# Addendum No. 07

April 15, 2024

## BAKERSFIELD COLLEGE STUDENT HOUSING (for DSA Project Name - New Residence Hall)

**PBK PROJECT NO.:** S2103400AR  
**DSA FILE NO.:** 15-C1  
**DSA APPLICATION NO.:** 02-122124

**BID**  
**ELECTRICAL ENLARGED POWER PLAN - LEVEL 02 - SOUTH**  
**E1.22**

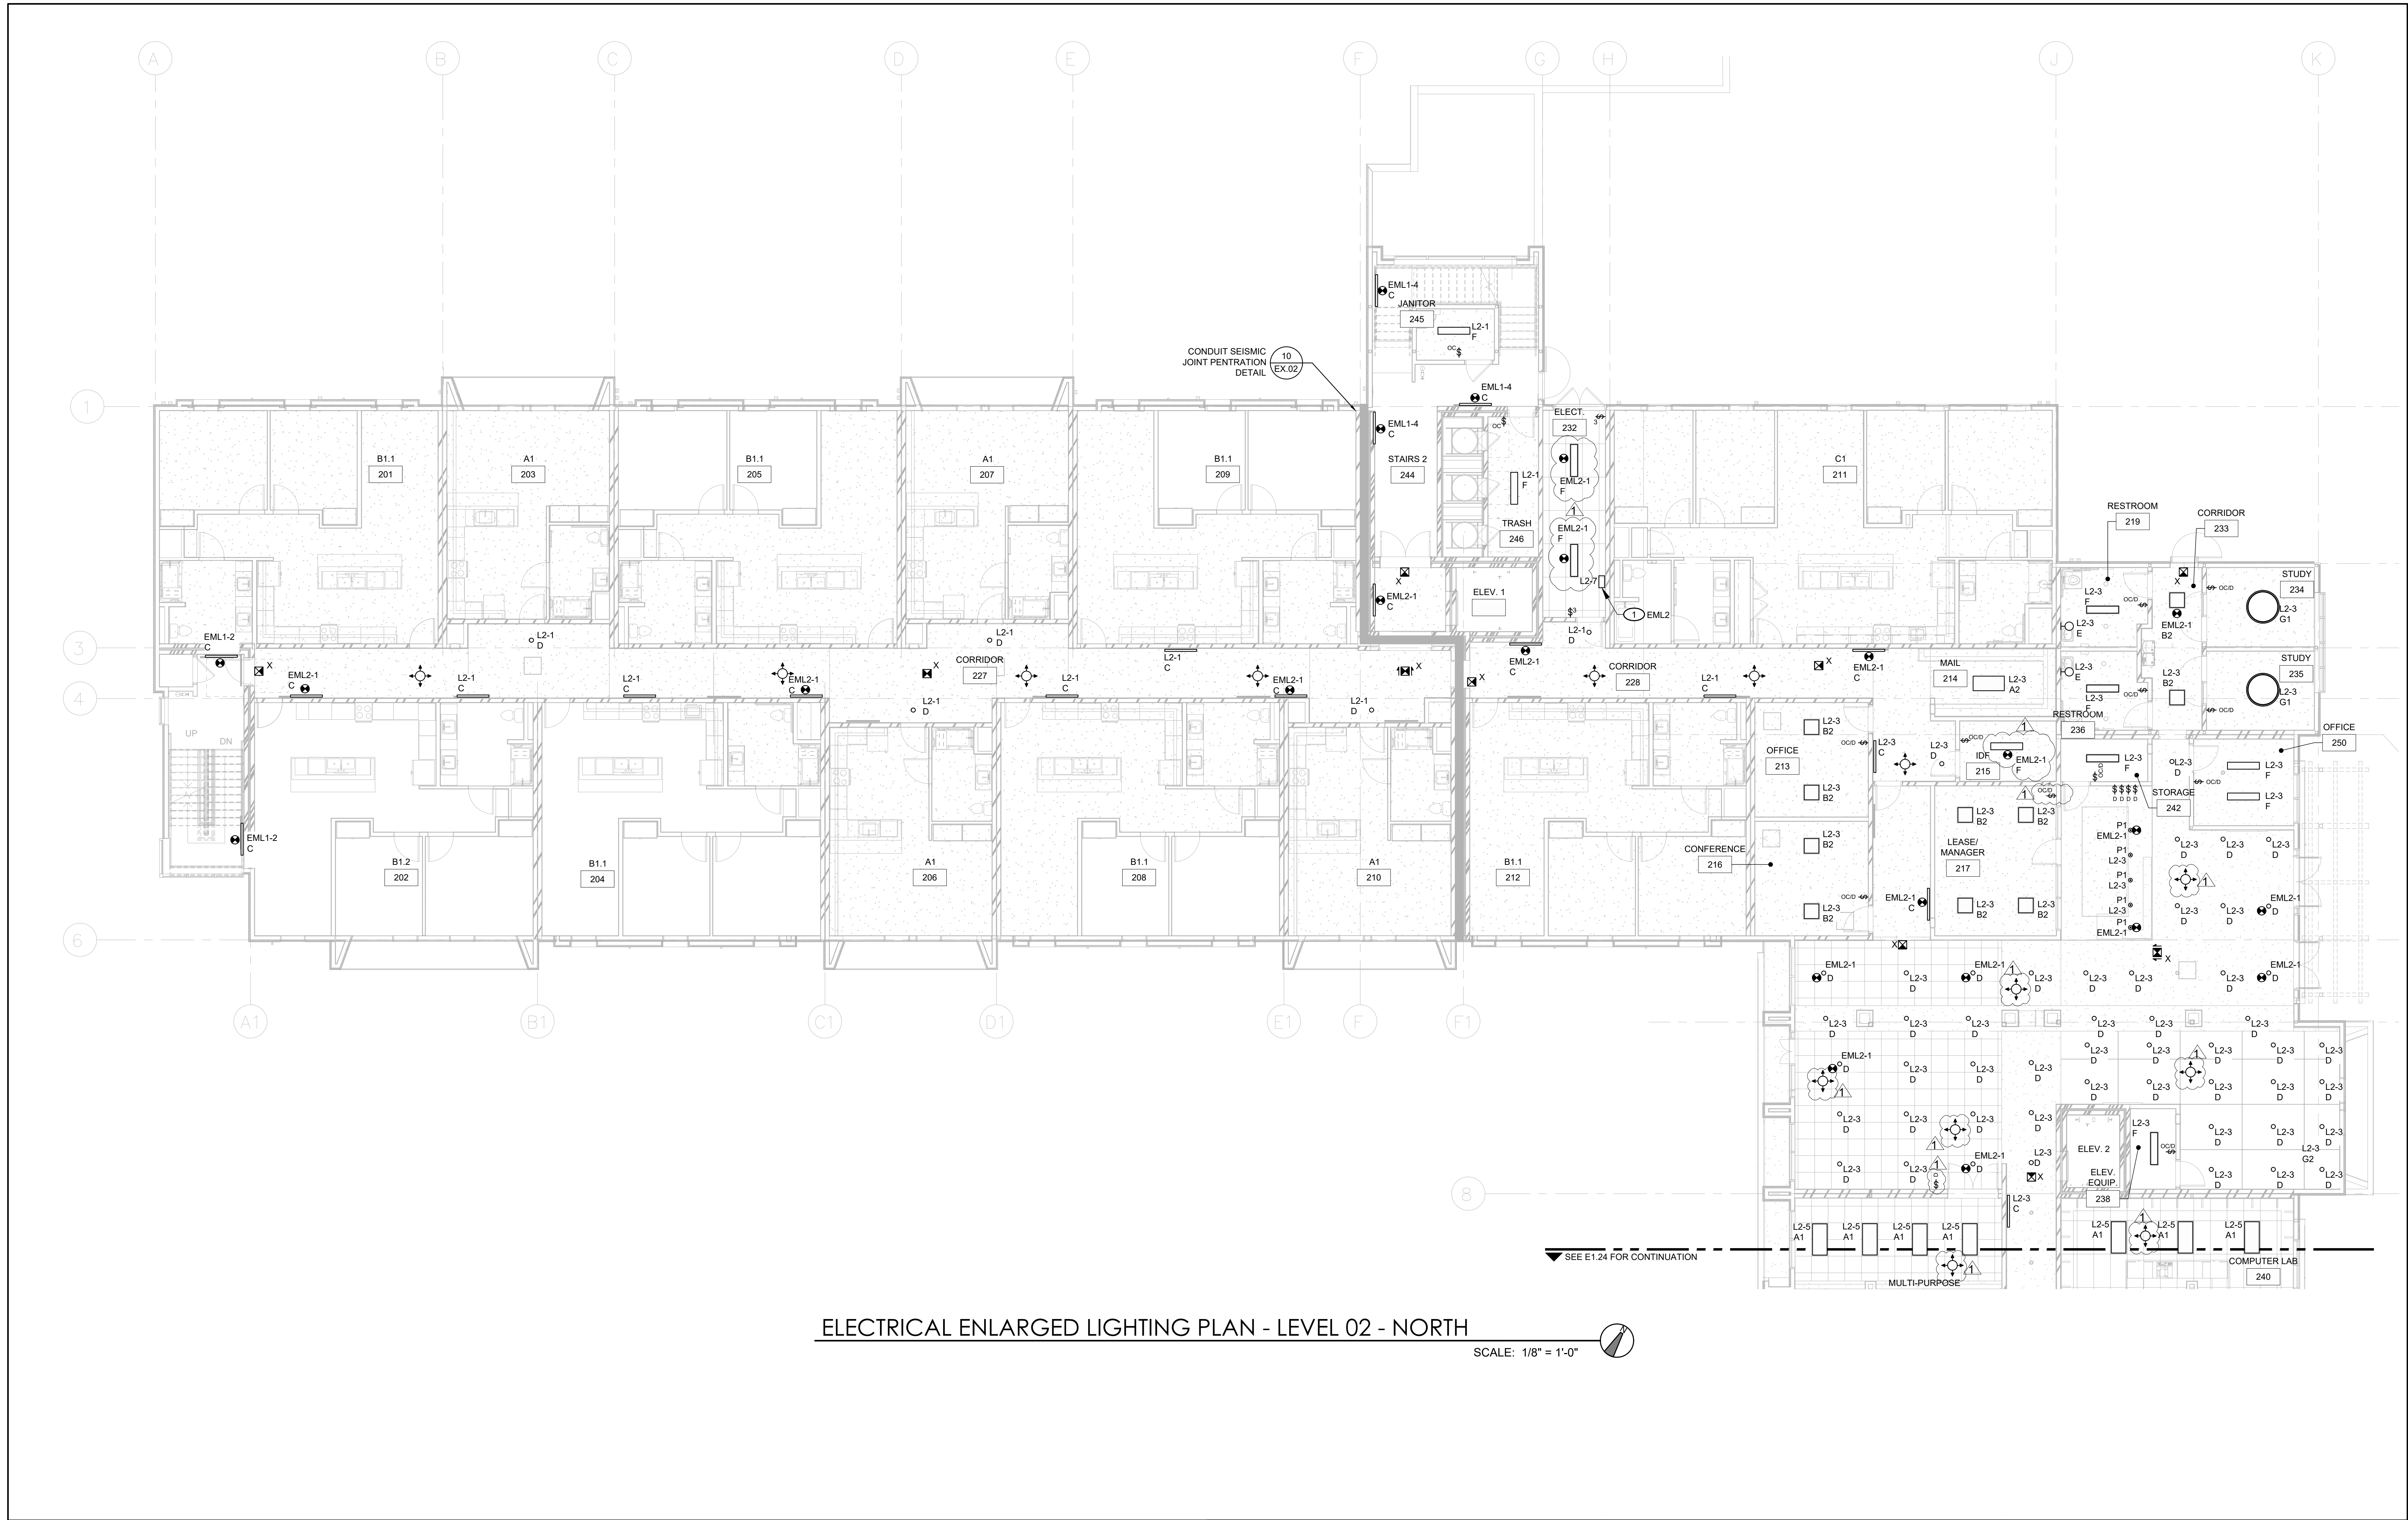
- AD7-01 E0.03 – ELECTRICAL ENLARGED SITE PLAN: ADD** Refer to clouded keynotes.
- AD7-02 E1.22 – ELECTRICAL ENLARGED POWER PLAN – LEVEL 02 - SOUTH:** Refer to clouded changes.
- AD7-03 E1.23 – ELECTRICAL ENLARGED LIGHTING PLAN – LEVEL 02 - NORTH:** Refer to clouded changes.
- AD7-04 E1.24 – ELECTRICAL ENLARGED LIGHTING PLAN – LEVEL 02 - SOUTH:** Refer to clouded changes.
- AD7-05 E1.32 – ELECTRICAL ENLARGED POWER PLAN – LEVEL 03 - SOUTH:** Refer to clouded changes.
- AD7-06 E1.33 – ELECTRICAL ENLARGED LIGHTING PLAN – LEVEL 03 - NORTH:** Refer to clouded changes.
- AD7-07 E1.43 – ELECTRICAL ENLARGED LIGHTING PLAN – LEVEL 04 - NORTH:** Refer to clouded changes.

CLIENT KCCD - BAKERSFIELD	
PROJECT NUMBER SZ103400AR	
DATE 03/22/2024	
#	REVISIONS
	DESCRIPTION
	DATE
	ADDENDUM 07 04/15/24
BID	
ALT. NO. 1 - TECHNOLOGY ENLARGED PLAN - LEVEL 01 - NORTH	
<b>T1.11A</b>

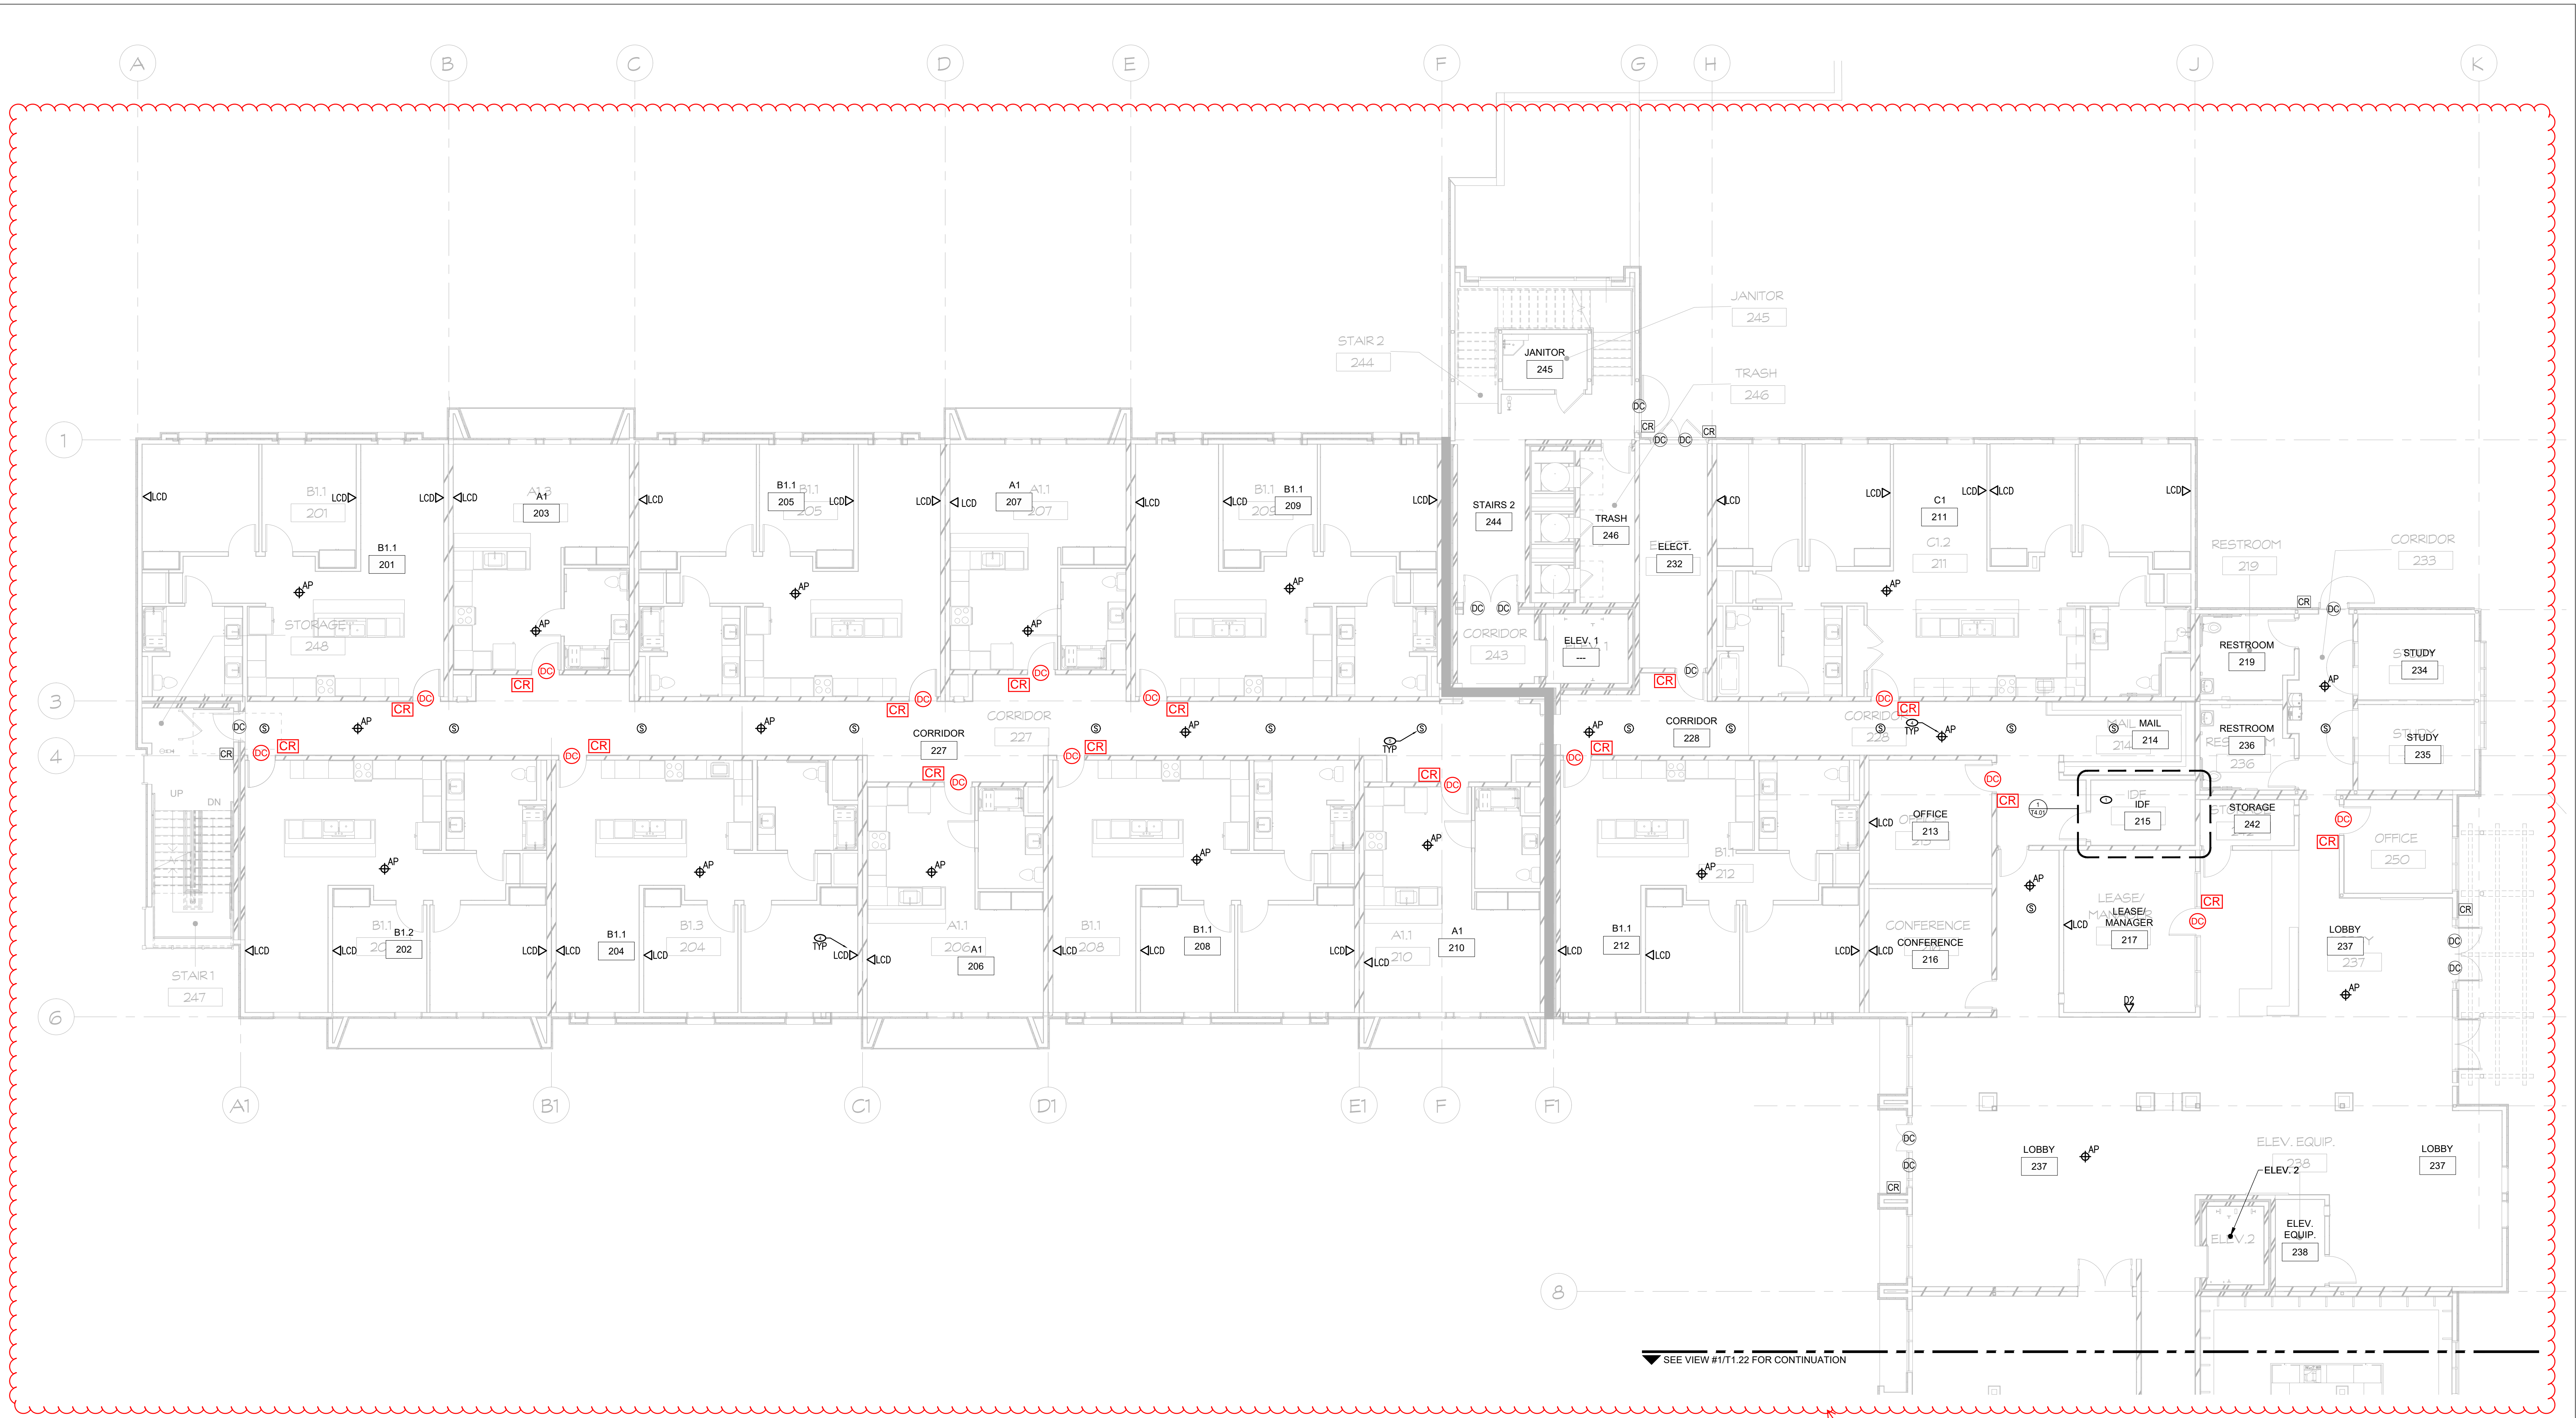
**AD7-10 T1.11A, T1.21, T1.22, T1.31, T1.32, T1.41, T1.42 – TECHNOLOGY SHEETS** the technology sheets have been updated to include added card readers and door contacts at all unit entry doors and at office doors. Changes are shown in red.
